Pipeline Safety: Valve Automation & Minimum  
Rupture Detection Standards

Docket No. PHMSA-2013-0255

**COMMENTS**

**FILED BY  
AMERICAN GAS ASSOCIATION  
AMERICAN PETROLEUM INSTITUTE  
AMERICAN PUBLIC GAS ASSOCIATION  
INTERSTATE NATURAL GAS ASSOCIATION OF AMERICA**

**Figure 1: Time to shutdown following rupture identification for PHMSA-reported onshore gas transmission incidents involving a rupture, 2010-2019.**

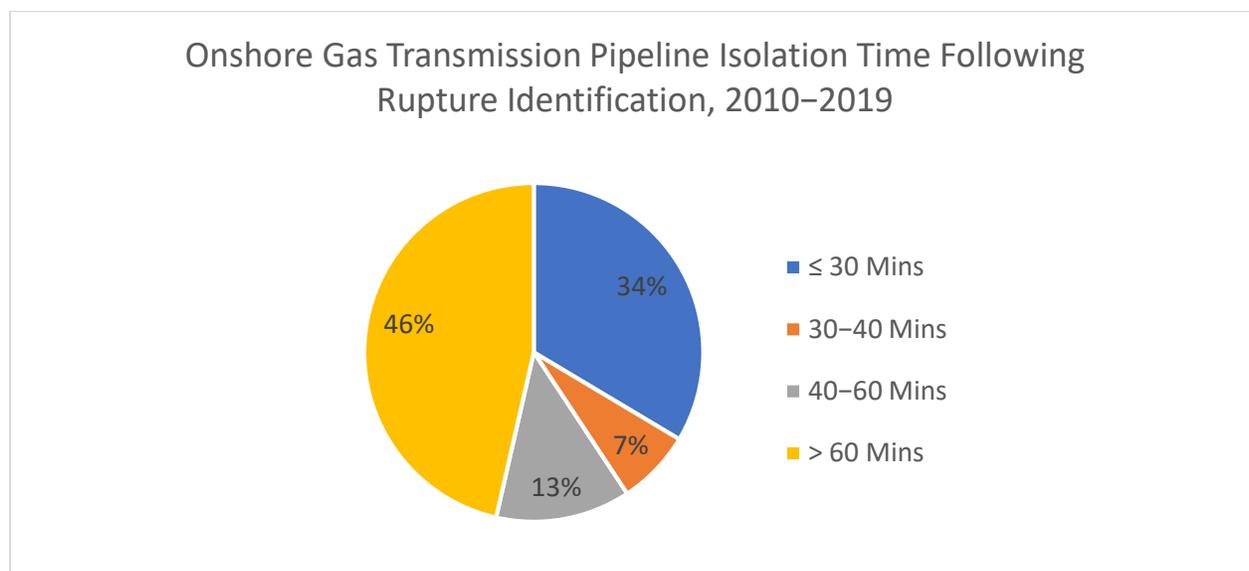
Since the early 2010s, many gas transmission operators have focused on achieving 60-minute response times in populated areas. INGAA members committed to doing so in 2011.<sup>46</sup> Multiple PHMSA special permits contain a 60-minute response time requirement.<sup>47</sup> Operators have proactively taken steps to attain the 60-minute response target while the current rulemaking has been pending for almost a decade. Operators should not be penalized for taking steps to enhance safety during the pendency of this rulemaking by now having to retroactively attain a 40-minute response time on existing pipelines.

Even for new and replaced pipelines, attaining the 40-minute response time will push the limit of what is currently technologically and operationally possible. Figure 1 below tabulates the response time following PHMSA-reportable onshore gas transmission pipeline ruptures from 2010–2019.<sup>48</sup> For almost 60% of ruptures, response time was greater than 40 minutes. The data below and the operational and technological experience of the Associations’ member suggest that a 40-minute response time would be impracticable for many existing pipelines today, as would any response time shorter than 40 minutes for new and replaced pipelines.
